SERVICE BULLETIN #41

SUBJECT: Swaged Fittings on the Cross Brace Cables

APPLICABILITY: All Float Equipped Kitfoxes

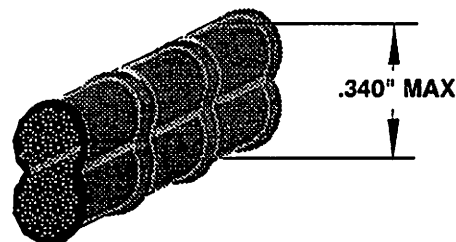
A float equipped Kitfox suffered a brace cable failure during a very hard water landing. The cable failed by pulling through the swaged nico press sleeve. Since these sleeves are rated for the full breaking strength of the cable, our investigation focused on the swaging procedure itself.

Before operating your float-equipped Kitfox again, inspect the swaging on the sleeves of the cross brace cables P/N 66021.000 for proper compression. The distance across the widest part of the oval in the swaged areas must be no greater than .340". If you find a sleeve that is improperly swaged and have access to a swaging tool, you can re-swage the sleeves to the proper depth. If you do not have a tool available, return the cables to us, and we will re-swage and return them to you. (Please call Customer Service for a RMA number before sending your cables to SkyStar for re-swaging). Upon successful inspection or re-swaging of your cable sleeves, note compliance with this bulletin in your aircraft logbooks.
